## INTRODUCTION

Since the introduction of the THM 440-T4 Transaxle in April, 1984, there have been many major engineering design changes. These changes have affected nearly every part used in the THM 440-T4. This Update Handbook will explain each change, the parts affected by the change, and any parts interchangeability problems created by the change.

### THM 440-T4 PUMP INFORMATION

Figure 53

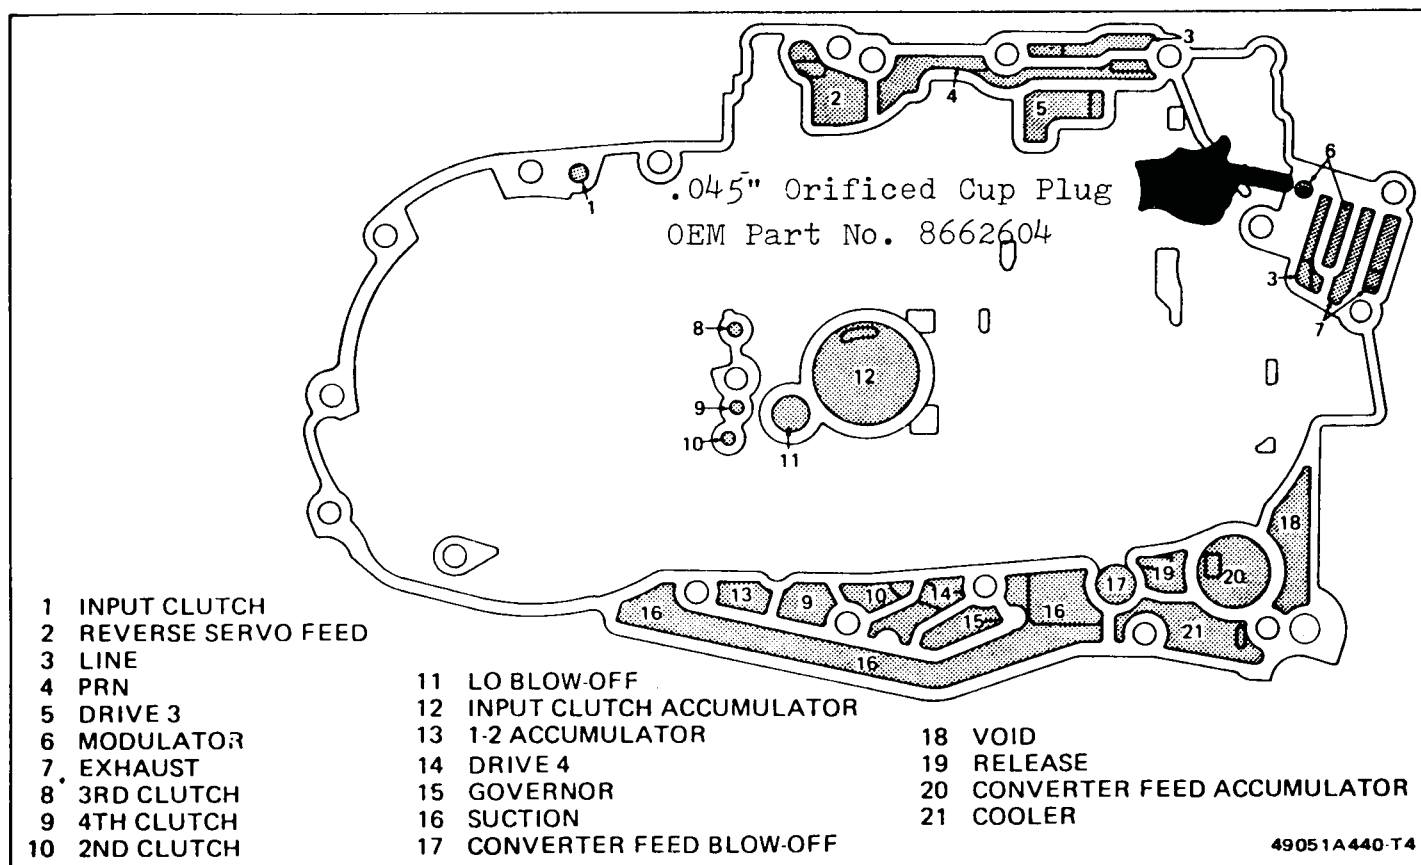
- 1) Vacuum Modulator - Late design has plunger sticking out of modulator (See Figures 54 and 55).
- 2) Modulator Valve - Redesigned to be compatable with "Plunger" style modulator. (Stem Removed--See Figures 54 and 55).
- 3) Channel Plate - Orificed cup plug added to channel plate to stabilize modulator valve action (See Figure 53).

Figure 54

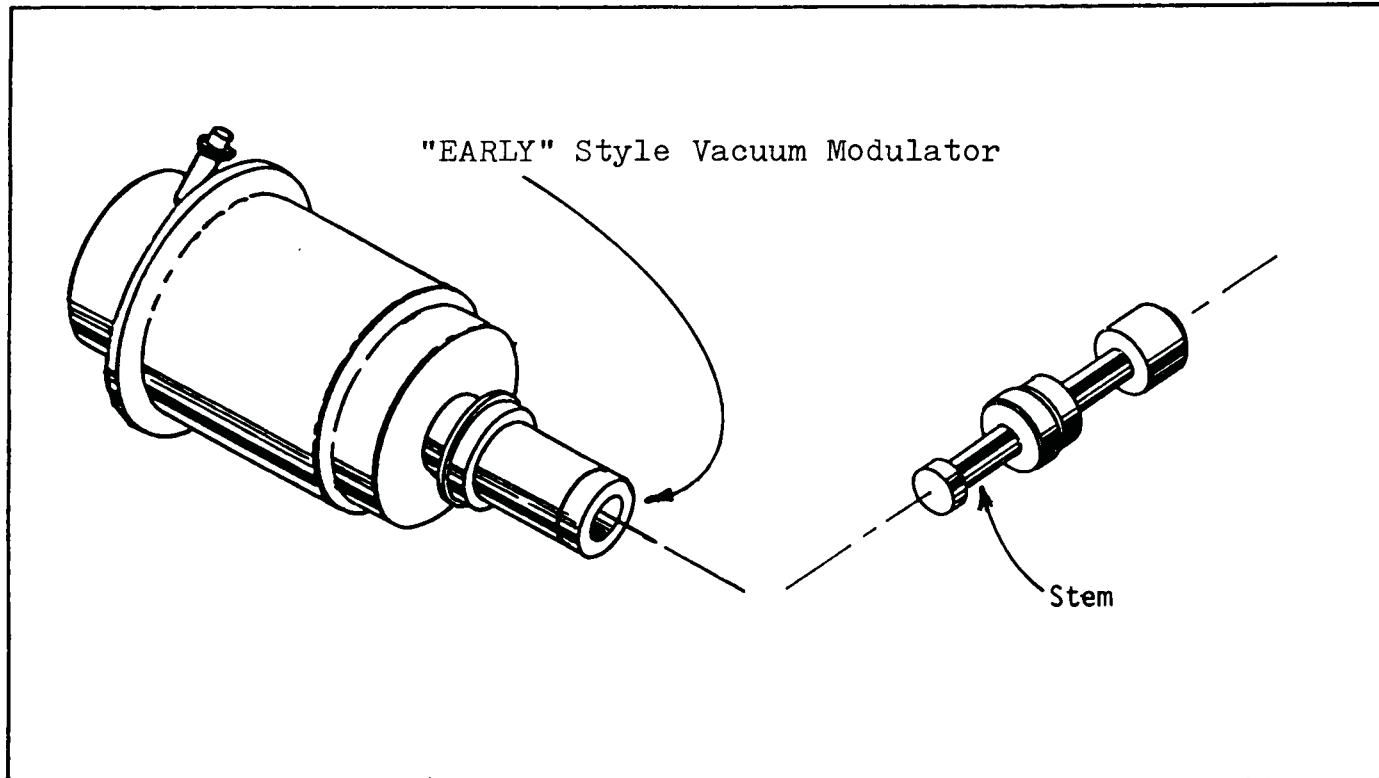
Change: Modulator redesigned on the end that goes into transaxle.  
(Compare Figures 54 and 55). Occured Approx. July, 1986.

Figure 56

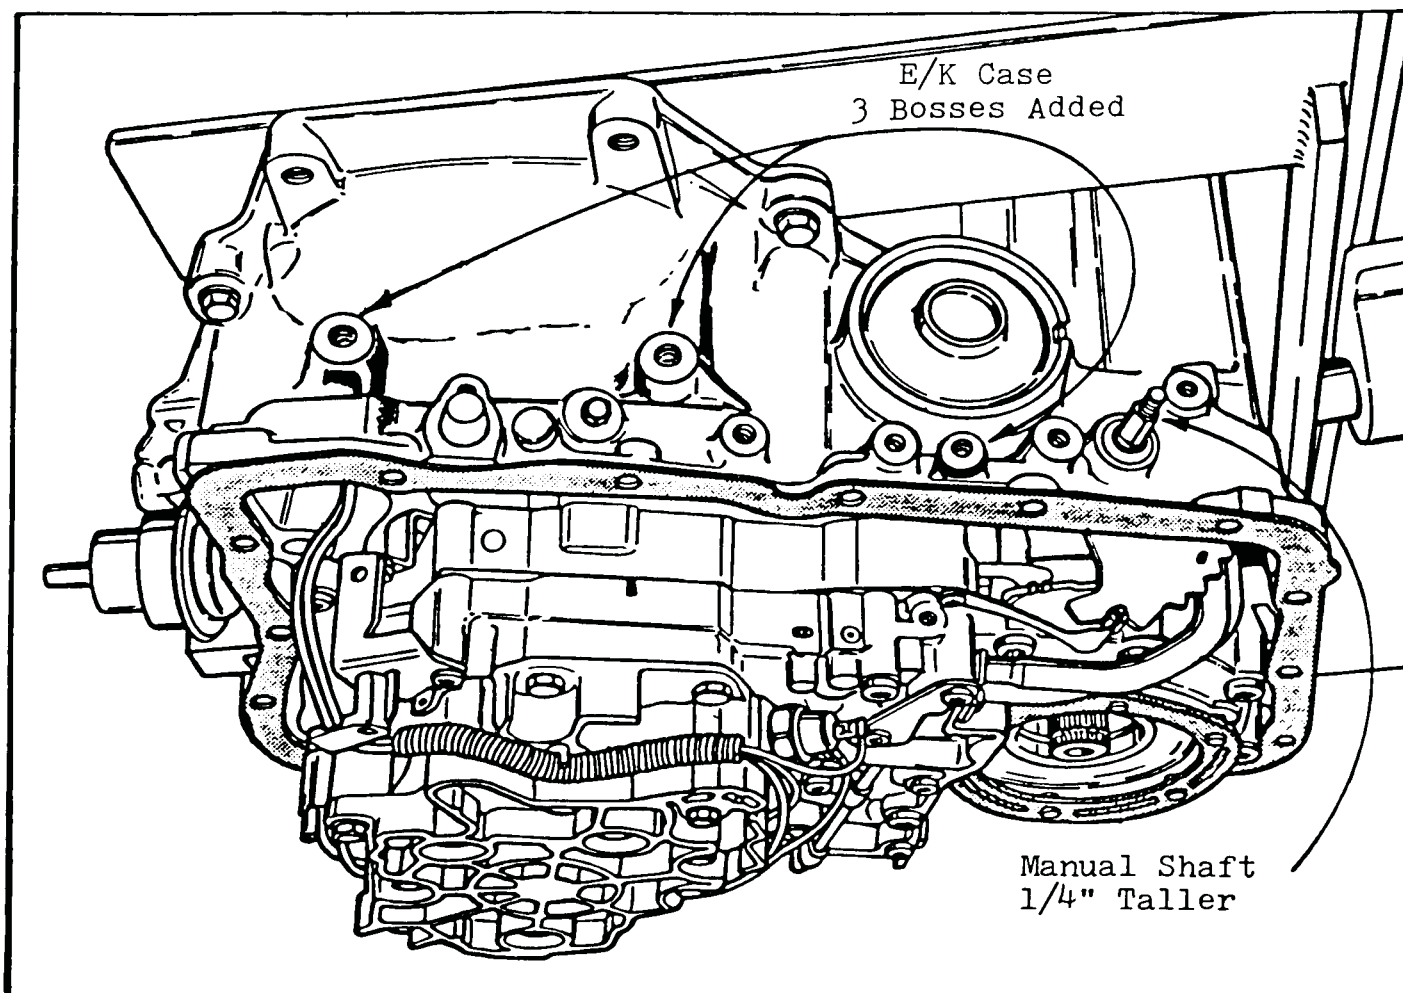
**Change:** Transaxle Case Assembly - 3 bosses added to transaxle case assembly (See Figures 56 and 57).

- 1) Transaxle Case - 3 bosses added to the case assembly (See Figures 56 and 57). The larger bosses on top of the case are for mounting purposes in the "E" and "K" bodies only. The smaller boss is for fuel line bracket in the "E" and "K" bodies only (See Figure 56). We can immediately see why it is called the E/K case.
- 2) Manual Shaft - The manual shaft is 1/4" longer on the E/K cars only.

Figure 58

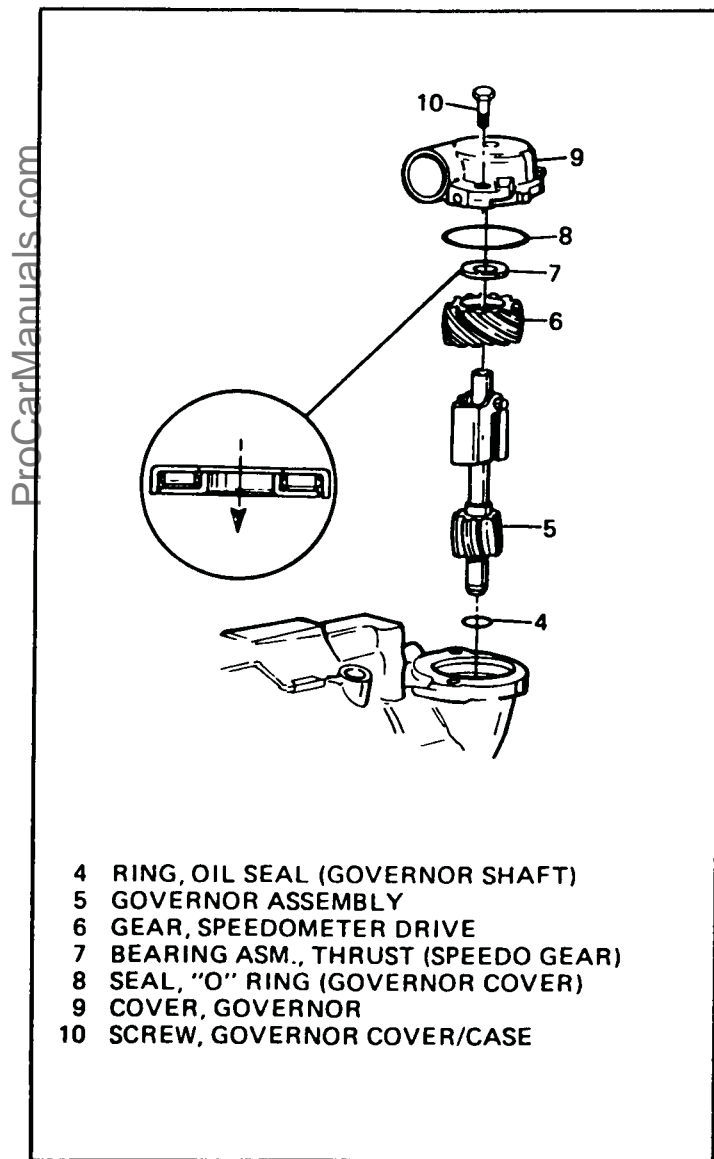
- 1) Governor Cover - Redesigned and speed sensor added to governor cover (See Figures 58 and 59).
- 2) Speedometer Gear - Replaced by 14 tooth rotor (11 Tooth on Allante) That is pressed on governor shaft (See Figure 59).

Figure 60

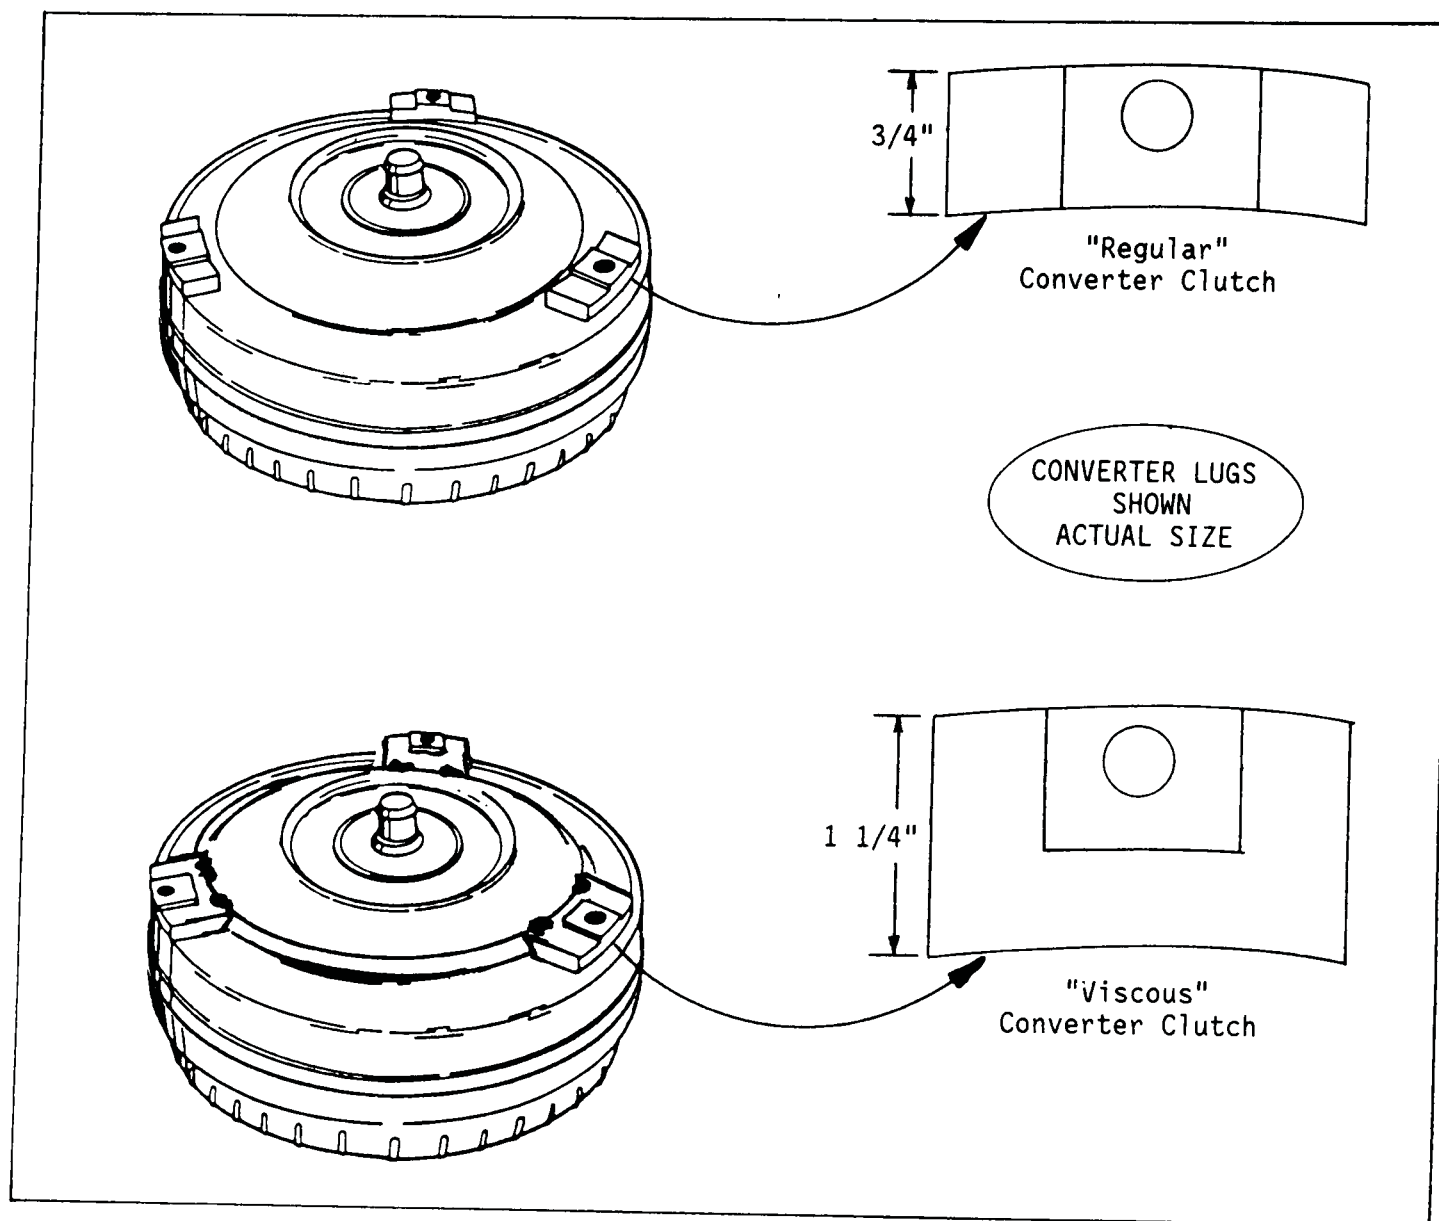
Identification of the "VISCOUS" converter from the "REGULAR" converter, can be done very easily externally. Notice the difference in the size of the converter drive lugs (see Figure 60). The profile of the converter covers are also different, but takes a closer look to detect, than do the drive lugs.

Figure 67

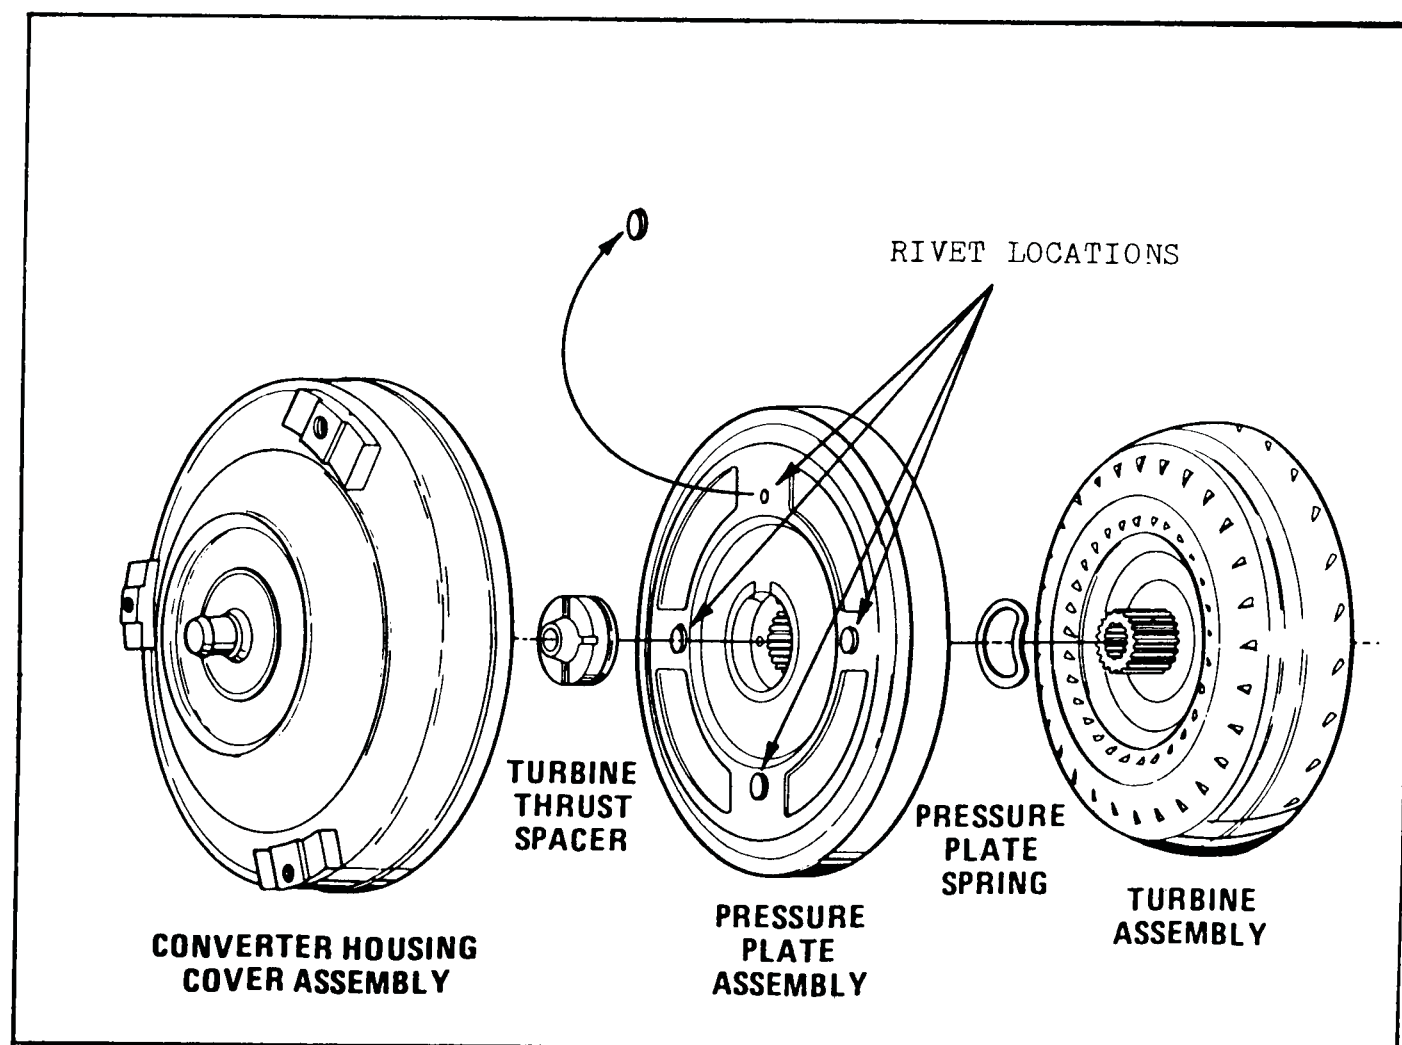
Some models of the THM 440-T4, usually with the 3.8L engine, may exhibit a TCC shudder condition or no torque converter clutch, because of a rivet head popping off that retains the damper assembly to the pressure plate (See Figure 67).

Figure 68

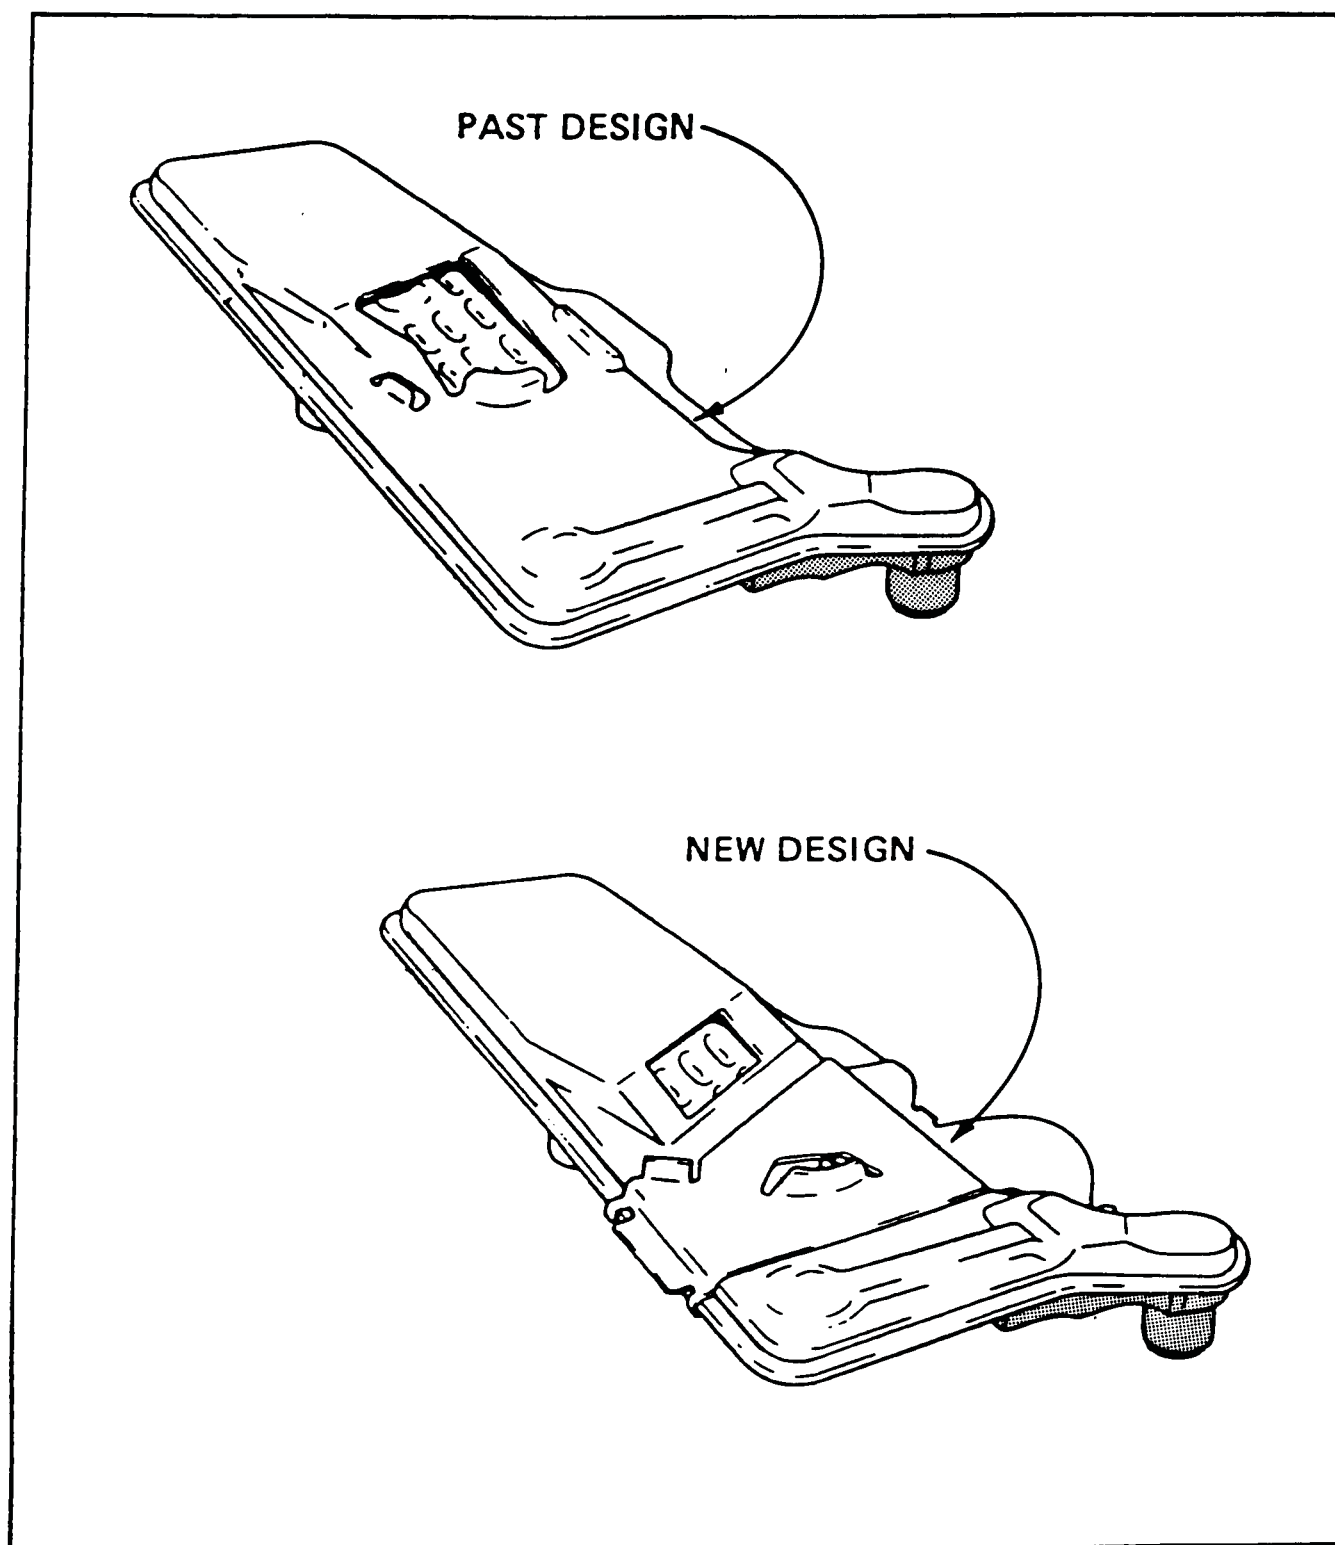
CHANGE: Oil Filter Assembly - Added baffles to oil filter and revised inlet (See Figure 68).

Additional baffles were installed on the new design filter and the inlet was revised (See Figure 68). Starting April 6, 1987 (Julien Date 096), all THM 440-T4 transaxles were built using the new design filter with the new inlet and baffle design.
